ENCLOSURES:  
Request for change to tech specs.....consist of Title changes within the station organization....and Changes to the Station organization chart, Fig. 6.1-1

PLANT NAME: Oconee

Re: Oconee Nuclear Station  
Docket Nos. 50-269, -270, -287

OCONEE NUCLEAR STATION  
STATION ORGANIZATION CHART  
FIGURE 6.1-1

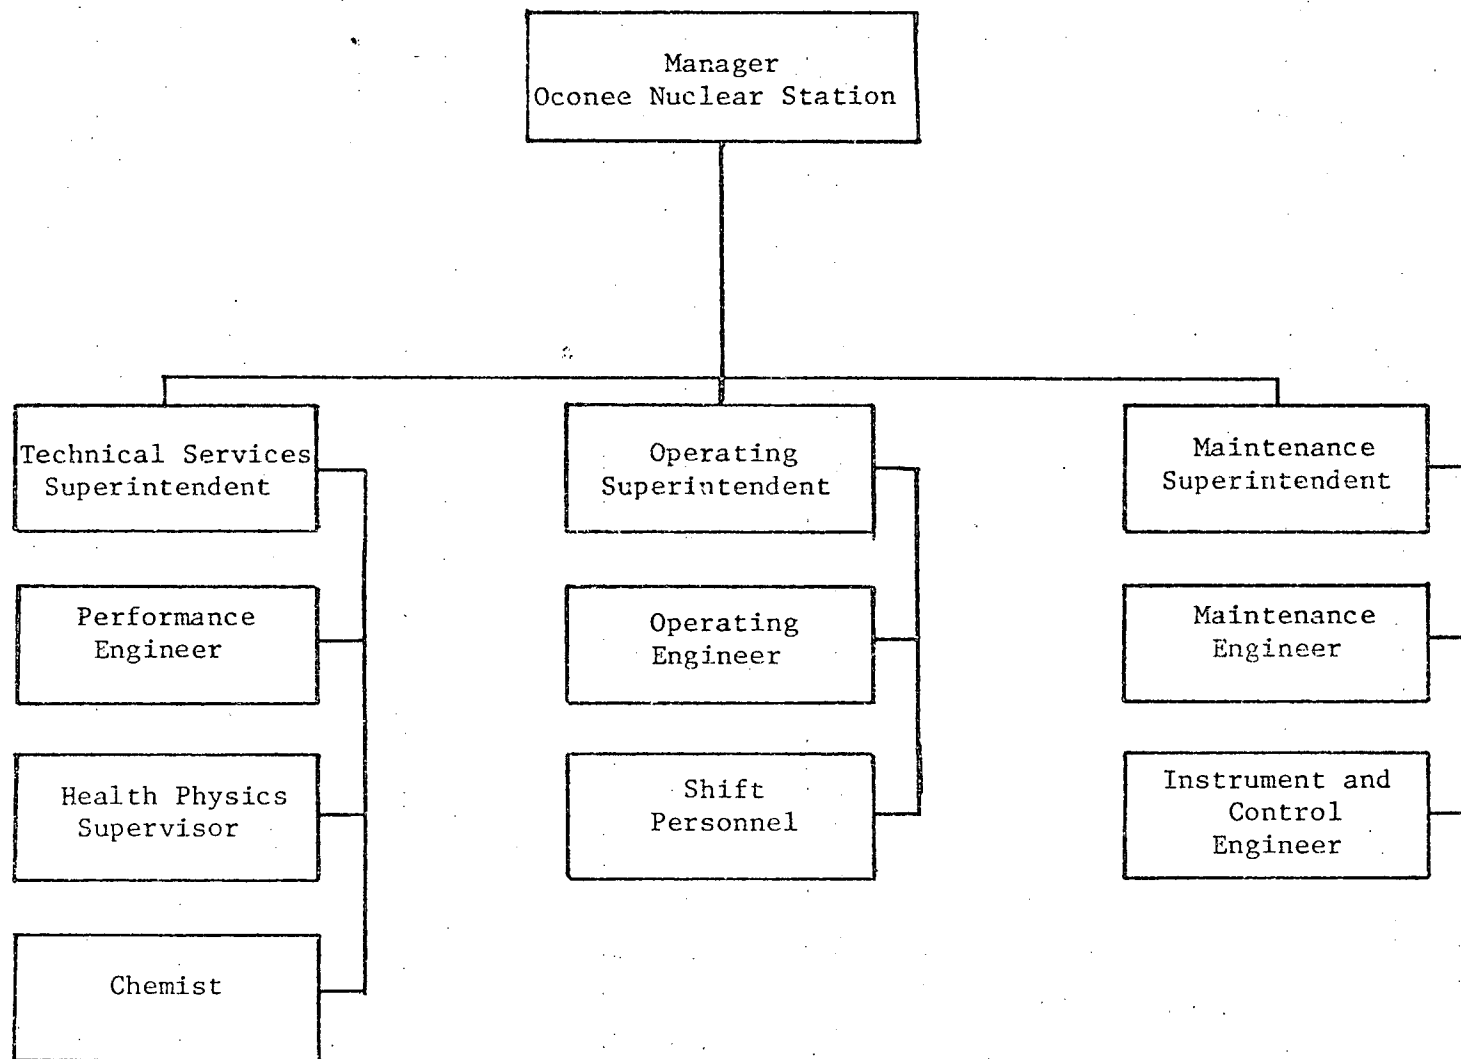
1. Title changes within the station organization such as Superintendent to Manager, Technical Support to Technical Services, etc.
2. Changes to the station organization chart, Figure 6.1-1.

6.1.1.3 The station organization for Operations, Technical Services, and Maintenance shall be functionally as shown in Figure 6.1-1. Minimum operating shift requirements are specified in Table 6.1-1.
